### REMARKS

This responds to the Final Office Action dated March 16, 2010.

No claims are amended or cancelled. Claims 10-12 and 53-66 are pending in this application.

Applicant disagrees with the objection. Figure 7A of the application is reproduced below for reference.

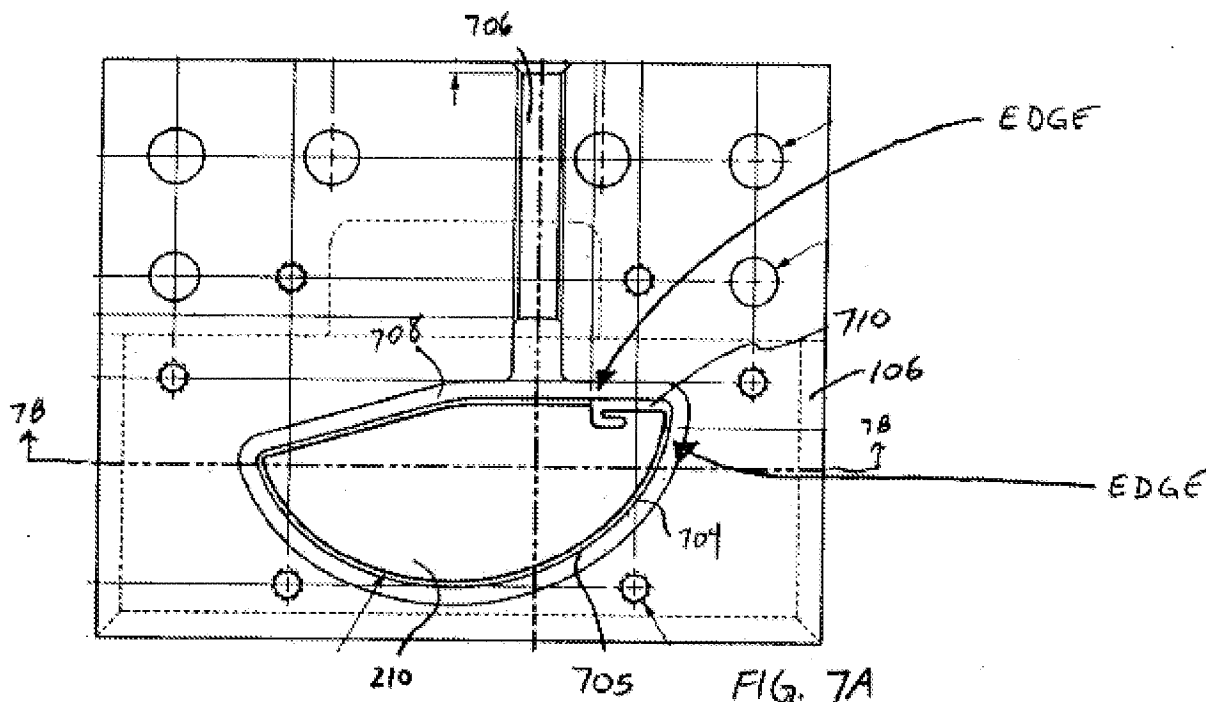
The drawings were objected to under 37 CFR 1.83(a). The Examiner noted that the drawings must show every feature of the invention specified in the claims. The Examiner stated that “the limitation of “the ridge including an opening to the interior of the die hole” in claims 10 and 65 must be shown or the feature(s) canceled from the claim(s).” (Page 2 of Final Office Action). The Examiner further stated “that element 705 represented a ridge does not have any discontinuous section to be called “an opening.”

As can be seen in Figure 7A, die hole 210 is surrounded by a lubrication dam 704, which is defined by a ridge 705. A feed conduit 706 feeds lubricant to a lubrication reservoir area 708. A pre-selected area 710 is open (i.e. ridge 705 does not extend through area 710) such that lubrication delivered via conduit 706 is directed towards hole 210 only through opening 710, while dam 704 holds the lubrication back around the rest of the periphery.

For reference, Applicant has pointed out the edges of the ridge 705 that define opening 710, which is located between the edges of the ridge.

Accordingly, the subject matter of “the ridge including an opening to the interior of the die hole” in claims 10 and 65 is present in the specification; and element 705 representing a ridge does have an opening 710.

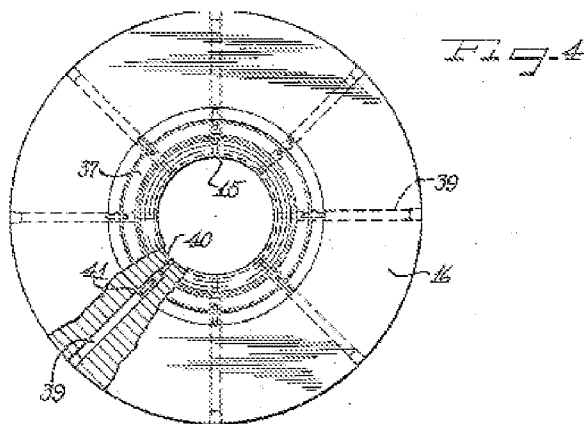
Claims 10, 12, 64 and 65 are rejected under 35 U.S.C. 103(a) as being unpatentable over the Tsubota (U.S. Patent No. 5,361,660) in view of Lyon (U.S. Patent No. 2,821,156).

In the Lyon reference, lubricant is delivered to the upper portion of the die to annular groove 37 by eight symmetrical passageways 41. (See Fig. 4 below; and col. 2, line 60 – col. 3, line 2). Thus groove 37 is filled equally all around with lubricant. Groove 37 includes an inner wall that extends around the entire periphery of the die hole and therefore does not include any openings to the interior of the die hole, as recited in claim 10. Instead, lubricant goes onto the workpiece from the top of the groove 37 as the piece is being stamped.

Accordingly, the combination of references does not include or suggest a ridge that does not extend around the entire periphery of the upper end of the die hole such that the ridge includes an opening to the interior of the die hole so as to direct the lubricant from the lubrication reservoir area behind the ridge to the interior of the die hole at the opening in the ridge, as recited in claim 10.
